S E R V I C E   B U L L E T I N

IS-29D / CO-7

Type : IS-29D Glider

Object : Fuselage Drain Holes

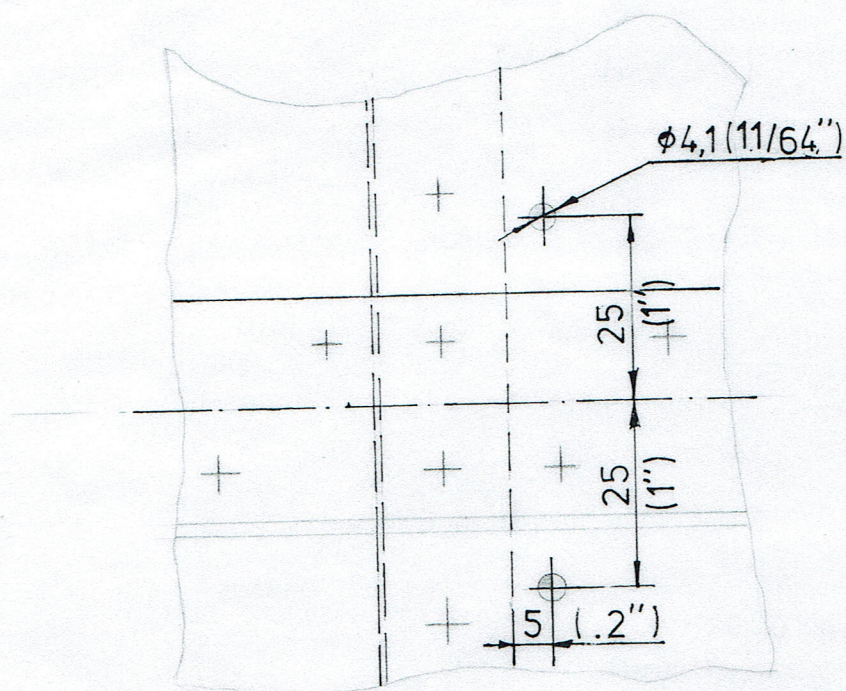
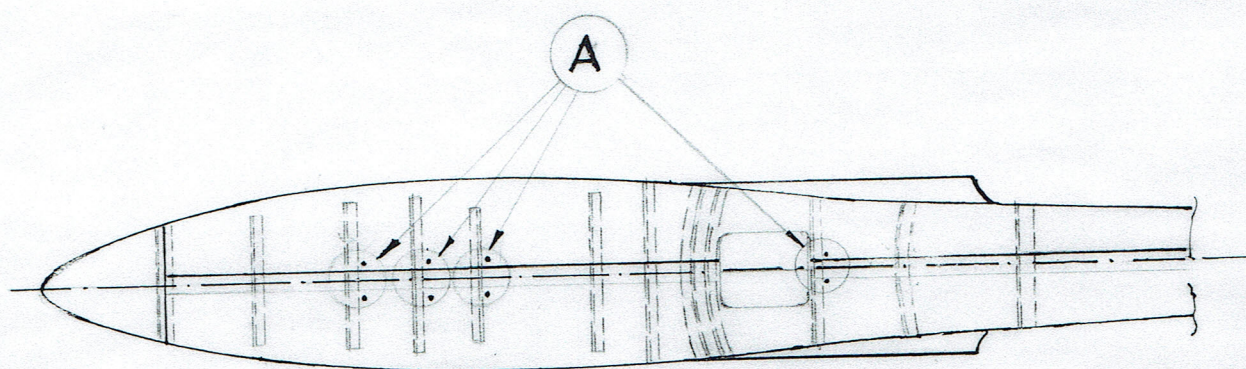
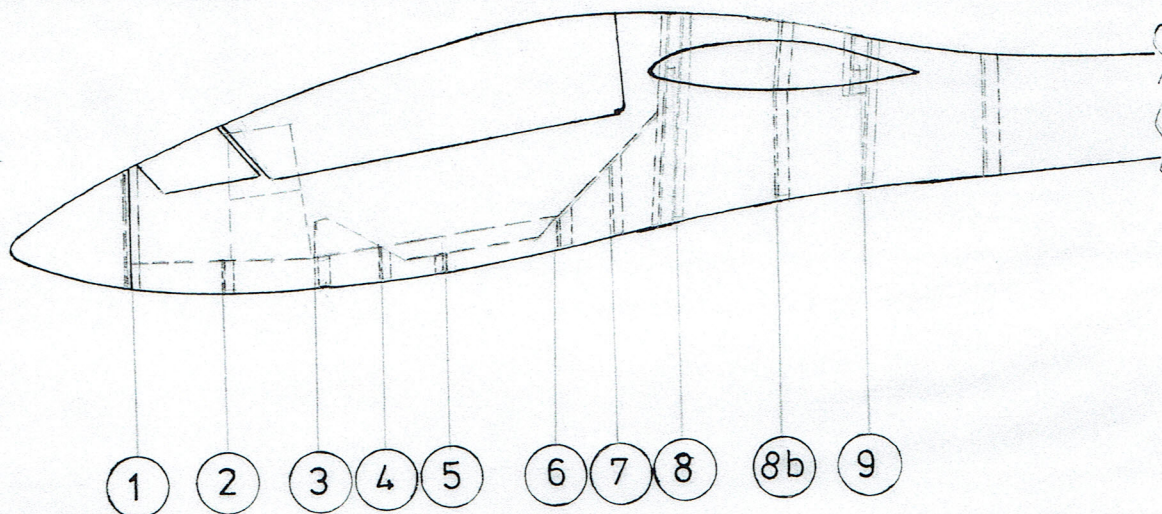
The modification consists of drilling the drain holes as the sketch on the page 3/3 indicates.

On the panels no.3, 4, 5 and 8b, mark the points using the drawing and then, drill the drain holes.

Use a drilling machine and a 4.1 mm (11/64") dia. drill. Remove the covers located in the cockpit and on the fuselage.
